6 September 2021

218316

## **WESTMEAD CATHOLIC COMMUNITY EDUCATION CAMPUS (SSD 10383) RESPONSE TO ADDITIONAL INFORMATION AND DESIGN AMENDMENTS**

**Figure 1 – Revised site plan**

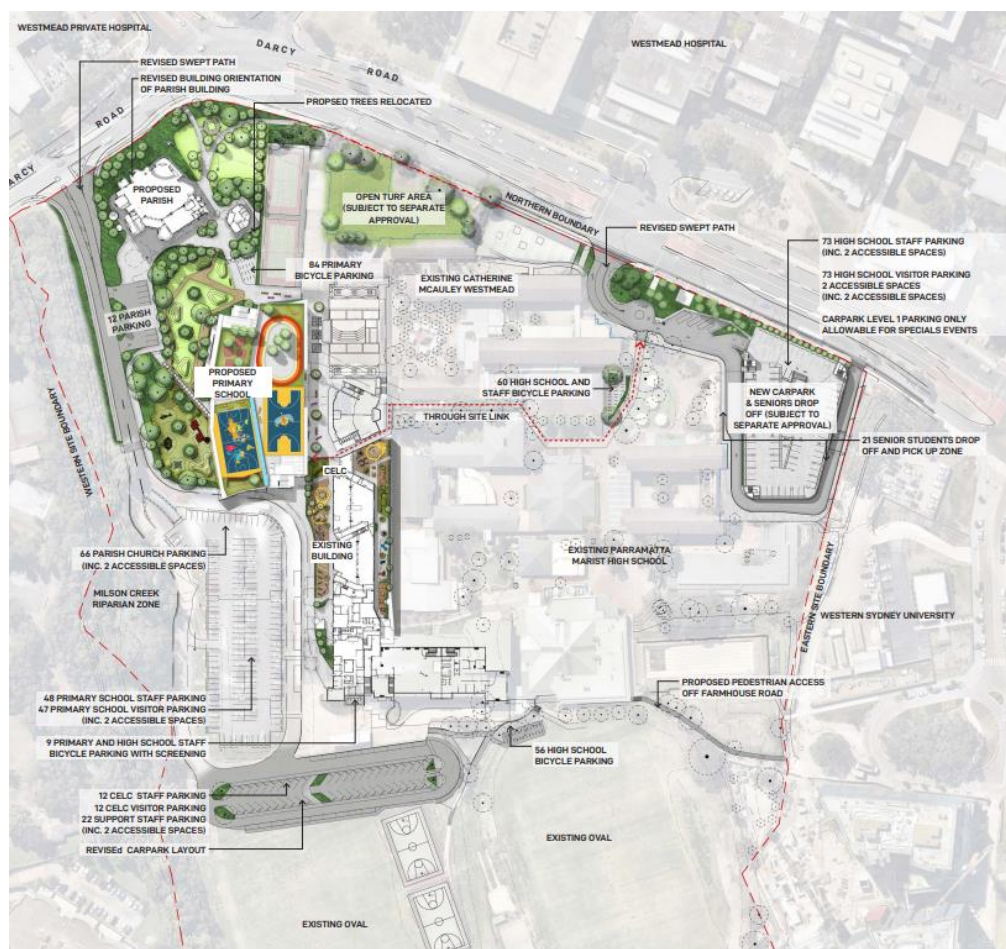
A revised site plan is provided at **Figure 1** for context.

**Figure 2 – Concept design for Darcy Road – Mother Teresa intersection**

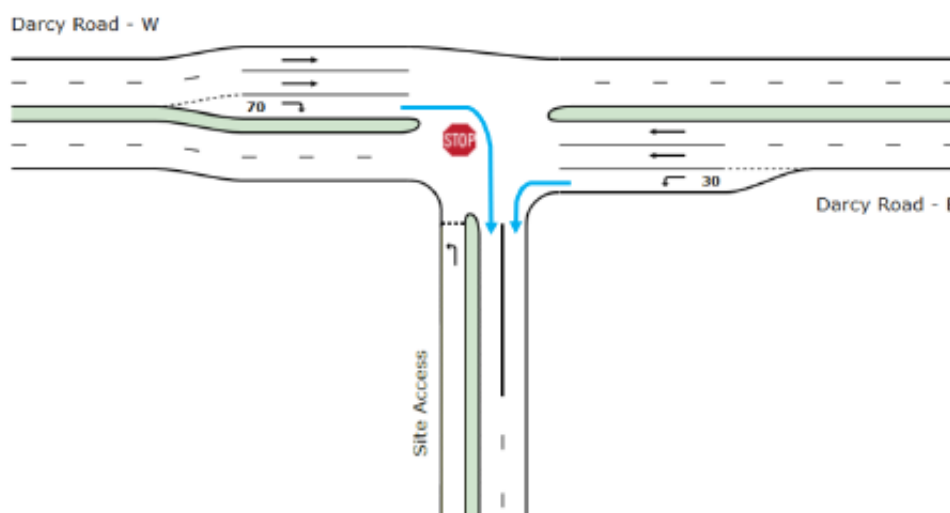
A mitigation measure to reduce the delay for the right-turn movement would be to provide a second exit lane on the south approach as shown in **Figure 2**. A second exit lane (turning left into the site) would provide the right-turn movement with a travel lane separate to the left-turn movement into the site access. This would allow the turning movements into the site access to occur simultaneously. Therefore, the delay for the right-turn movement would be reduced since this movement would no longer be required to give-way to the opposing left-turn movement. A sensitivity test of this measure indicates that the intersection level of service would be improved to LoS C (40 seconds average delay). In this scenario, the average queue length for the right-turn movement would be 19m.

The widening of the site entry road to accommodate the second exit lane has resulted in the Parish Church being repositioned, as described in **Section 3.3**.

The concept design has been subject to a RSA and has been reviewed by TfNSW. TfNSW has provided support for the proposed intersection design.

**Figure 3 – Concept design for Darcy Road – Catherine McAuley intersection**

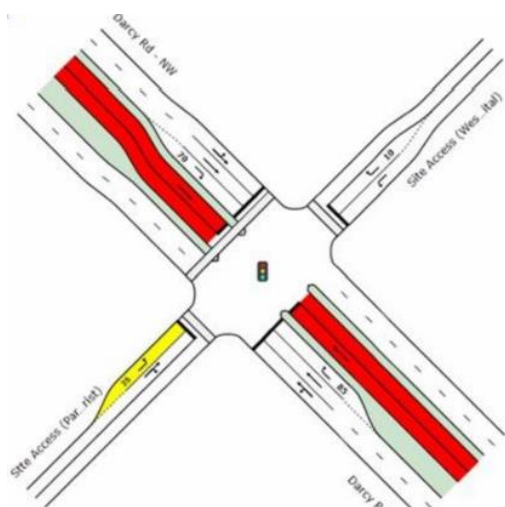
Modelling showed that this intersection would operate at LoS B or better in the future scenario. Nevertheless, TfNSW advised that they would not accept a significant reduction in green time for the Darcy Road main carriageway.

An alternative site access layout has been designed to achieve the same (or similar) green time for Phase A (the Darcy Road T-way movement). This arrangement includes a dedicated left-turn lane on the south-west approach of the intersection (site exit approach) to be provided as a 25m short lane. The concept layout of this intersection arrangement is shown at **Figure 3**.

The concept design has been subject to a RSA and has been reviewed by TfNSW. TfNSW has provided support for the proposed intersection design. The new concept design for this intersection differs from the design that was approved by the Sydney Central City Planning Panel under the Early Works DA (DA/241/2020). Options for implementing the revised design are discussed further in **Section 4.2**.

**Figure 4 – Upgraded pedestrian connection to Farmhouse Road**

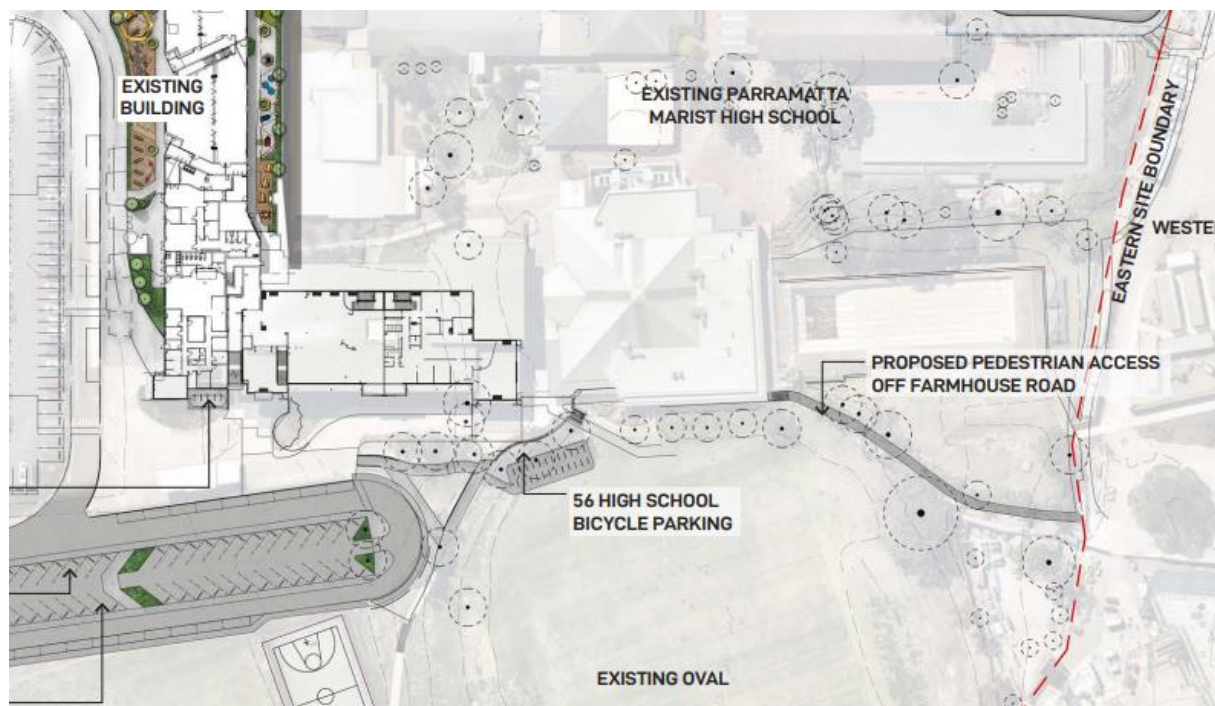
In response to comments from Council regarding the need for improved east-west connections into and through the campus, an upgraded pedestrian link is proposed between the WCC site and Farmhouse Road (refer to **Figure 4**). This will form the second main pedestrian access on the east side of the WCC site. The link will provide a more direct connection for students and staff walking to and from the site from the east and south-east. Having consideration for existing and future residential development in the Westmead Precinct, as well as existing and future transport connections, the upgraded Farmhouse Road link will significantly enhance site accessibility and permeability.
